The user manual for EV3635B

Rev 1.0

Picture 1

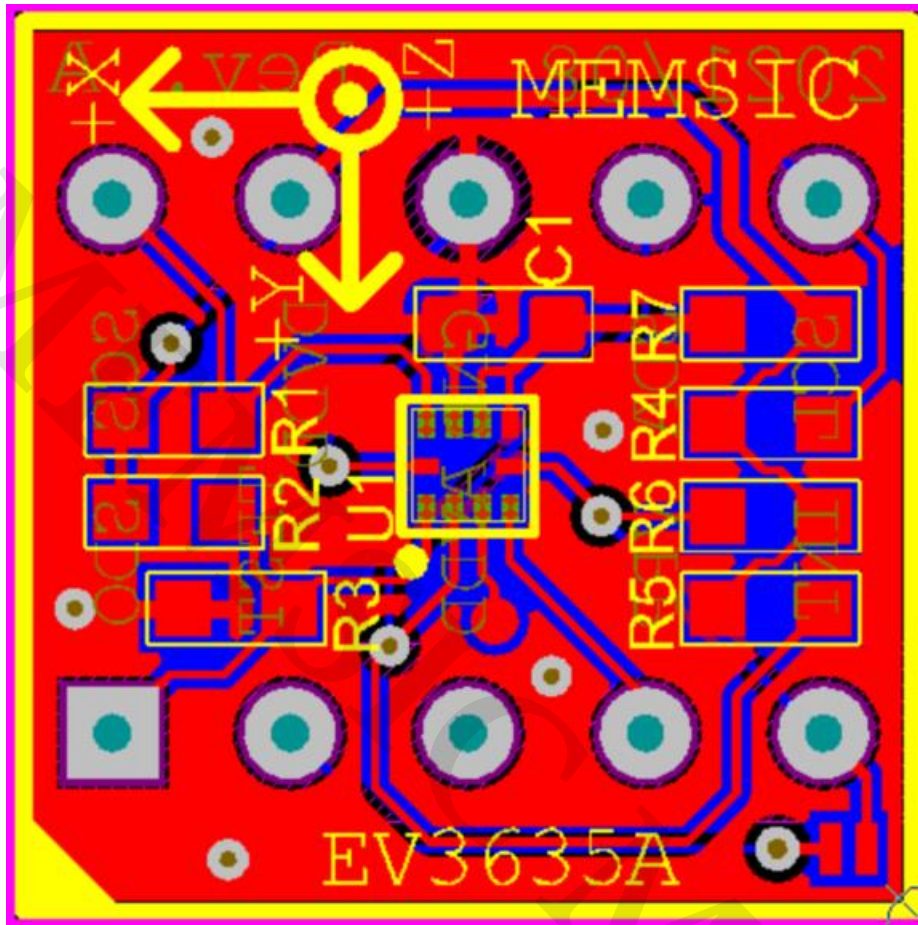
EV3635A (PCBA, PCB Assembly) and EV3635B (PCBA) use the same PCB, on which it is the same silk print “EV3635A” (refer to Picture 1 and Picture 2 below). The differences between EV3635A (PCBA) and EV3635B (PCBA) are that resistors’ values are different and whether the resistors are stuffed (refer to Table 1, Table 2, and Schematics below).

Since EV3635A (PCBA) is obsolete, all PCBA with the silk print “EV3635A” on PCB should be EV3635B (PCBA) when the print of the label on top of the packaging box is “EV3635B” (refer to Picture 3 below).

Interface (EV3635B)	R1	R2	R3
SPI or I2C 0x4C (Factory Default)	100KΩ	DNI	10KΩ
SPI or I2C 0x6C	100KΩ	10KΩ	DNI
